Monticello Nuclear Generating Plant
Docket 50-263
License No. DPR-22

Response to Request for Additional Information for a License Amendment Request for
Contingent Installation of a Temporary Fuel Storage Rack in the Spent Fuel Pool (TAC
No. MD0302)

STRUCTURAL RAI INFORMATION RESPONSE

MONTICELLO SPENT FUEL STORAGE POOL (40'x26')
PLAN
SCALE 1/8\"/>

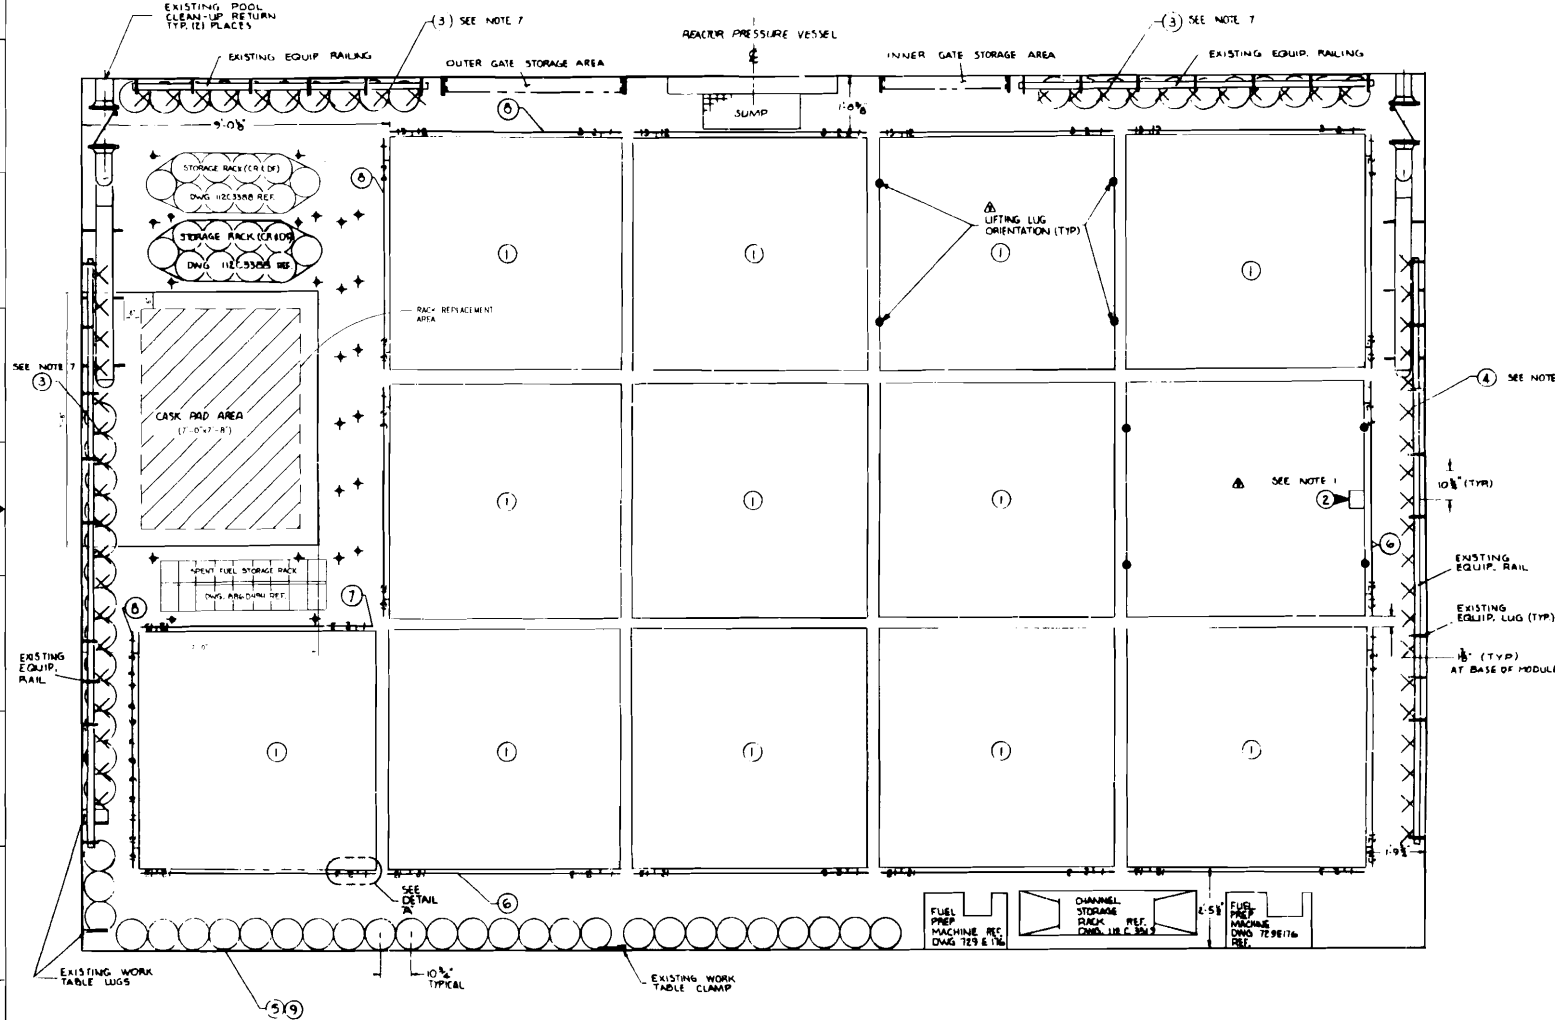
The location of the temporary 8x8 PaR fuel storage rack module in relation to the existing fuel storage rack modules in the SFP is shown on the mark-up of MNGP Drawing No. NX-7865-15-36, entitled High Density Fuel Storage System Installation Arrangement, and is provided in Enclosure 2.

FIGURE AA

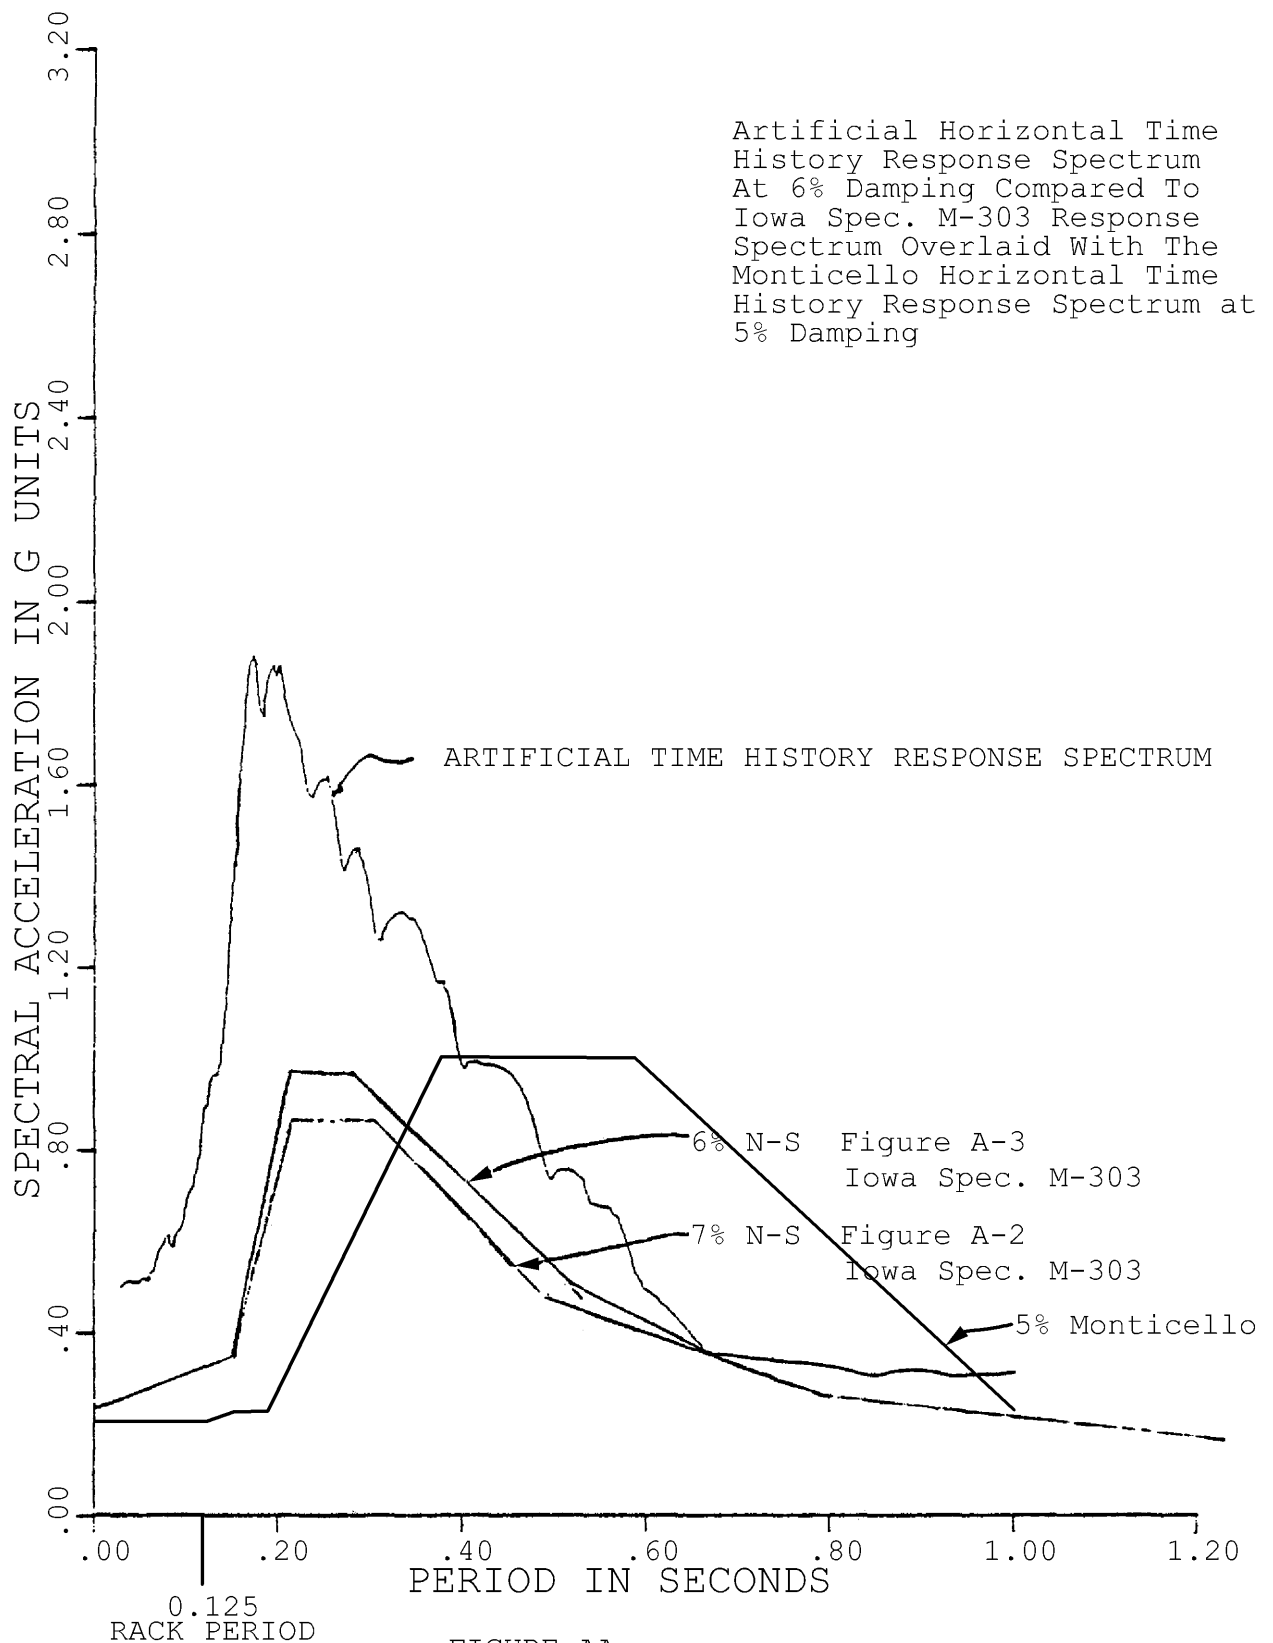
As shown in Figures AA and BB in Enclosure 2, the time history response spectrum used in the PaR analysis bounds the MNGP response spectrum in the frequency range of interest (i.e., the frequency range of the 8x8 fuel storage rack module). The first natural horizontal frequency of the fuel storage rack module analyzed by PaR was 8 hz (0.125 second period)

(see PaR Report, Section 5.3, "Model Description, Formulation and Assumptions for the Seismic Analysis of BWR Spent Fuel Racks," page 5.3-4). As shown on the plot, at this frequency of interest, the MNGP response spectrum is well below the time history response spectrum used in the PaR analysis. The first natural vertical frequency of the fuel storage rack module analyzed by PaR was 14 hz (0.07 second period) (see PaR Report, Section 5.3, page 5.3-4). Also, as shown on the plot, at this frequency of interest, the MNGP response spectrum is well below the time history response spectrum used in the PaR analysis. Accordingly, it is concluded that the seismic evaluations in the PaR Report are bounding for the MNGP. Therefore, the PaR 8x8 fuel storage rack module will withstand the MNGP SSE loads.
